Planning Board Minutes to the Meeting Mebane Municipal Building January 13, 2020 6:30 p.m.

RZ 20-04 Conditional Rezoning -Tupelo Junction (formerly "The Landing at Lake Michael)

Technical Memorandum Date: March 5, 2020 To: Montrena Hadley, Planning Officer From: Franz K. Holt, P.E. Subject: Tupelo Junction– City Engineer review

TRC NOTES:

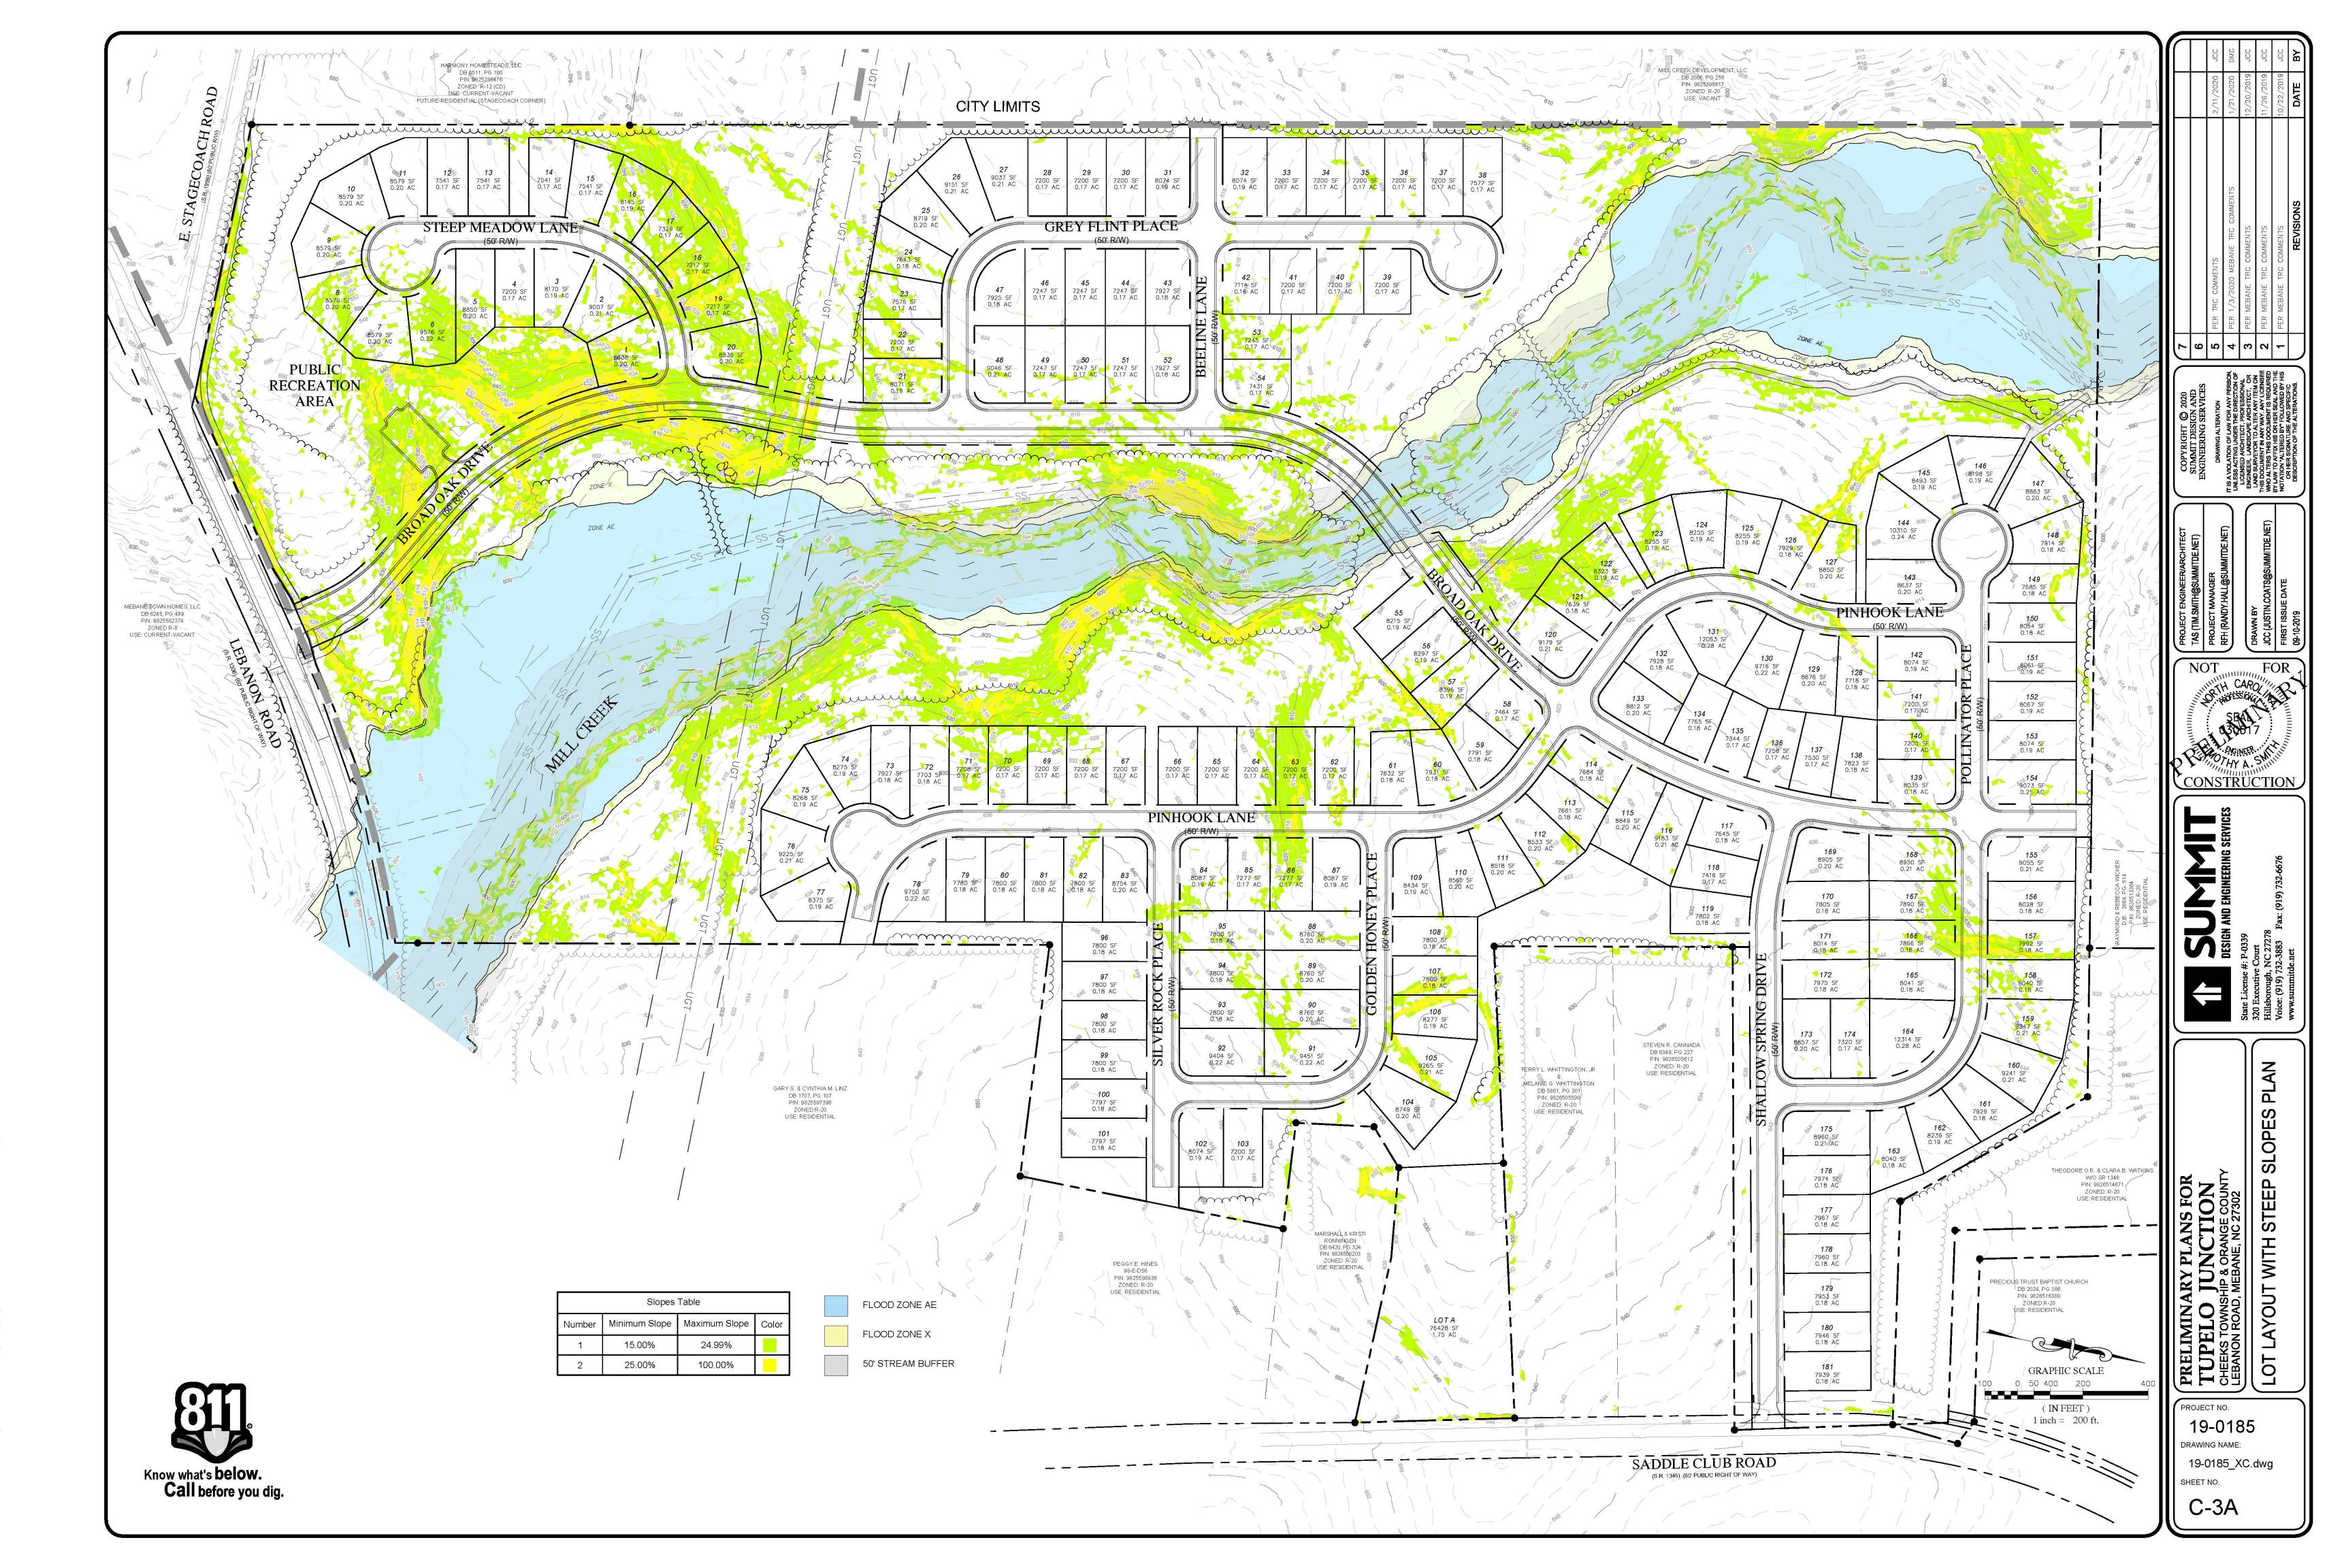
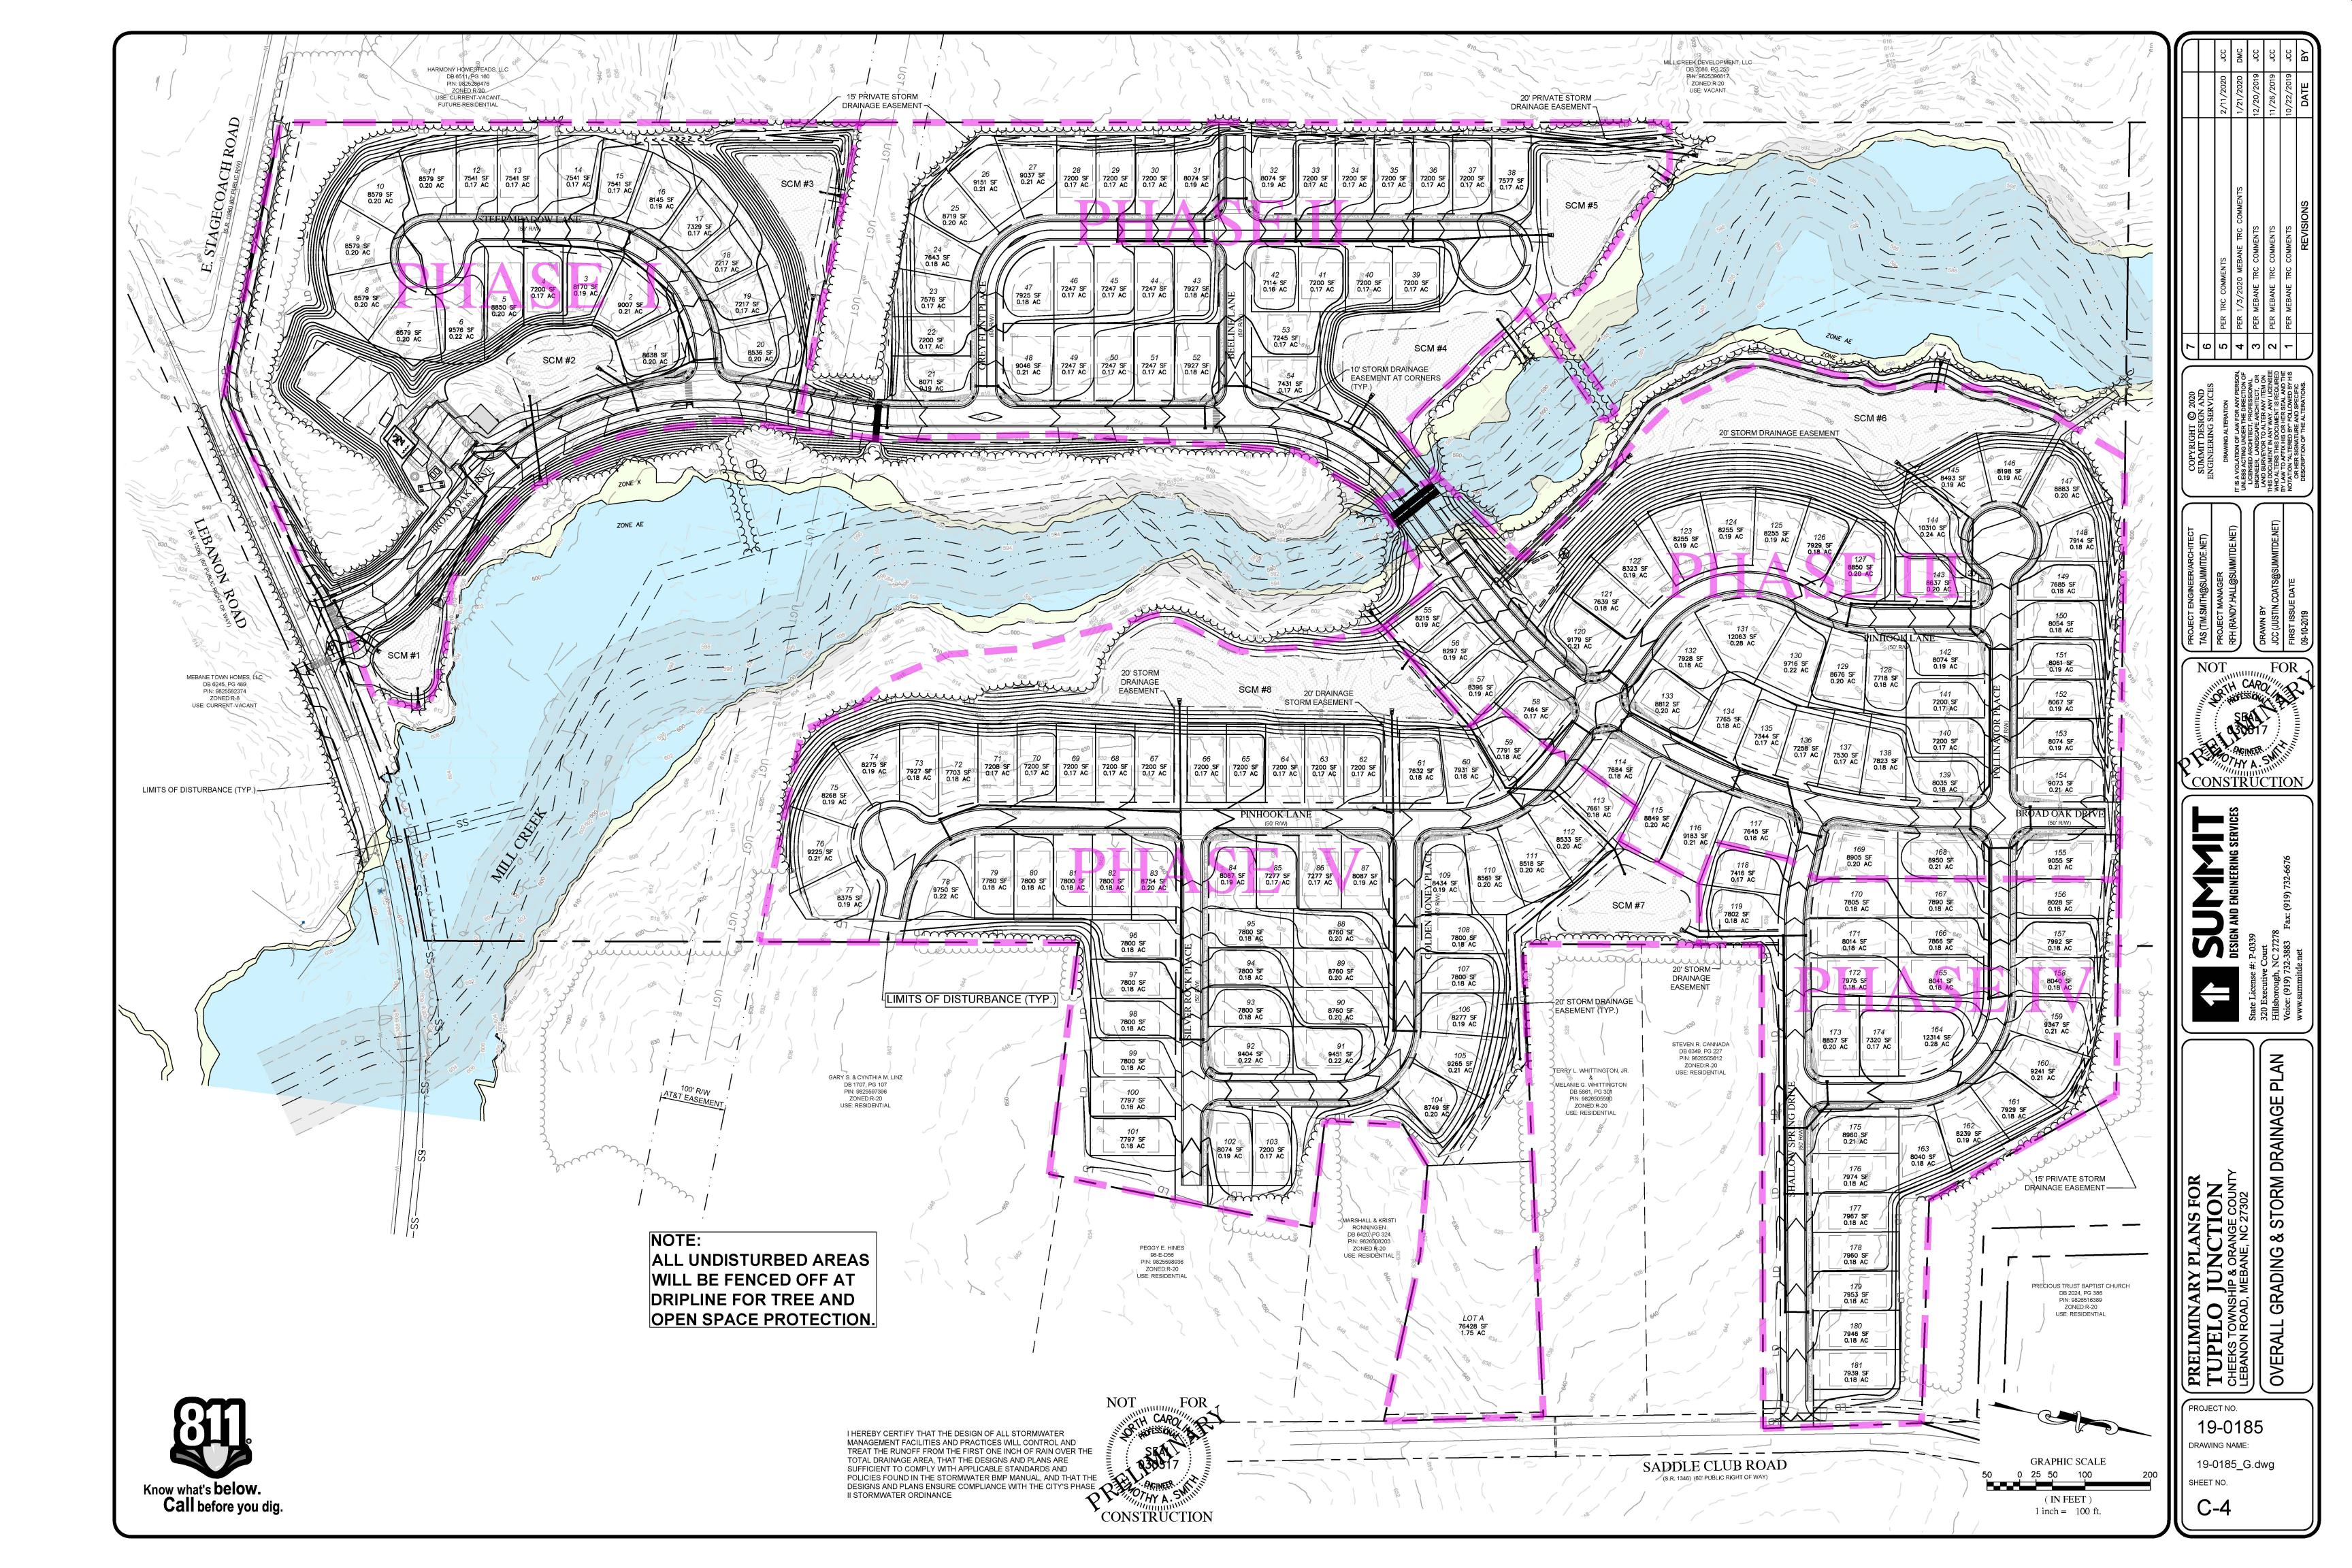
- 1. THE NEW CULVERT FOR ON-SITE CREEK CROSSING SHALL PASS THE 100 YEAR STORM WITHOUT TOPPING THE ROADWAY. SIZING AND MATERIAL TO BE DETERMINED WITH THE CONSTRUCTION DRAWINGS.

- 2. ALL NEW ROADS ARE CONSIDERED LOCAL RESIDENTIAL AS DETERMINED BY THE PROJECT TRAFFIC ENGINEER AND WILL BE BUILT TO CITY
- STANDARDS AND MAINTAINED BY THE CITY OF MEBANE AFTER FINAL ACCEPTANCE.

- 7. THE AMENITY AREA, PARKING LOT, AND STORMWATER CONTROL MEASURES SHALL BE SCREENED WITH LANDSCAPING AND/OR BERMS. ALSO, THE RECREATION AREA SHALL BE SCREENED FROM THE RESIDENTIAL LOTS WITHIN THE SITE. ALL SCREENING SHALL BE IN ACCORDANCE WITH THE MEBANE UDO AND WILL BE INCLUDED WITH THE LANDSCAPING PLANS PROVIDED WITH THE CONSTRUCTION DRAWINGS FOR APPROVAL BY THE CITY OF MEBANE. ANY STORMWATER CONTROL MEASURES THAT POND OR HOLD 2 FEET OF WATER SHALL BE FENCED FOR SAFETY.

- 8. A CULTURAL RESOURCES ASSESSMENT HAS BEEN PROVIDED BY THE THE NC STATE HISTORIC PRESERVATION OFFICE. NO HISTORIC RESOURCES WERE FOUND WITHIN THE PROJECT AREA. WE HAVE REQUESTED THEM TO TAKE ANOTHER LOOK INTO THE STAGECOACH ROCK AND ARE AWAITING THEIR RESPONSE. THE "STAGECOACH ROCK" HAS BEEN DEEMED AS A POSSIBLE SAFETY HAZARD TO VEHICULAR TRAFFIC BY NCDOT. RELOCATION OF THE ROCK SHALL BE COORDINATED WITH AND APPROVED BY N.C.D.O.T. THIS NEW LOCATION SHALL BE EITHER ON SITE OR AT LAKE MICHAEL PARK.

- 19. THE CURRENT PLANS INDICATE PRELIMINARY DRAINAGE EASEMENTS OVER PIPES AND ENGINEERED SWALES. AS PHASED CONSTRUCTION DRAWINGS ARE FINALIZED ALL DRAINAGE WAYS (5 CFS OR MORE) SHALL HAVE A DEDICATED DRAINAGE EASEMENT PER THE CITY OF MEBANE STORM SEWER DESIGN MANUAL WHETHER PIPED OR UN-PIPED.
